September 15, 2026

PAULDING FAMILY HEALTH CLINIC
Paulding, Ohio

C6-5091

ADDENDUM 1

ITEM NO. 1: Sheet A-401 – Enlarged Floor Plan, Interior Elevations, Accessories Schedule, Casework Schedule

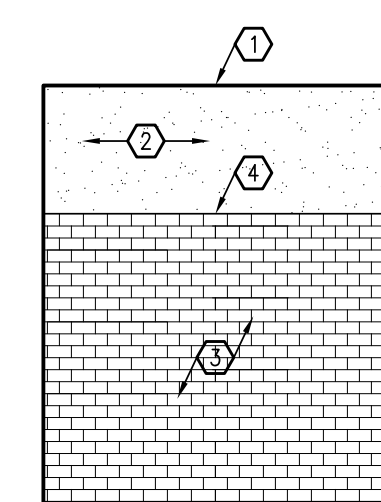
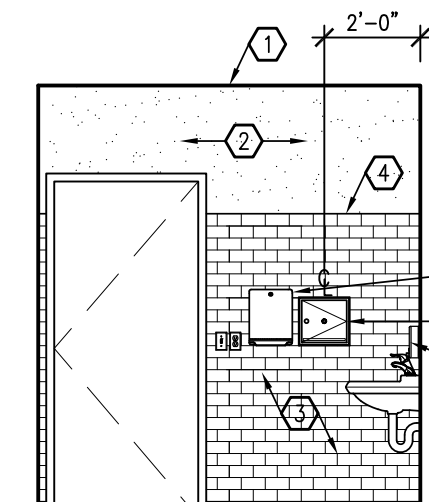
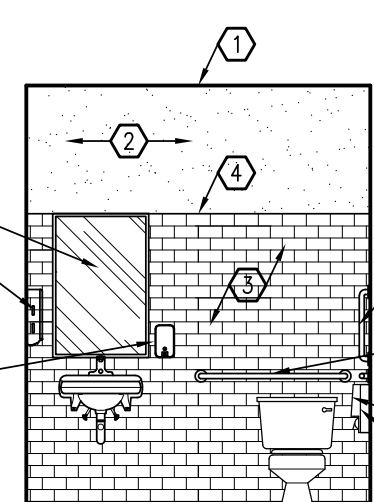
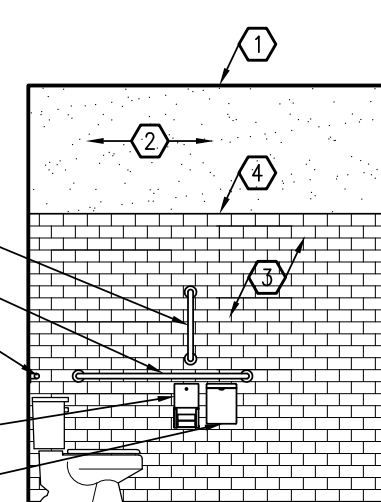
Refer to attached revised Drawing for Toilet Room elevation revisions.
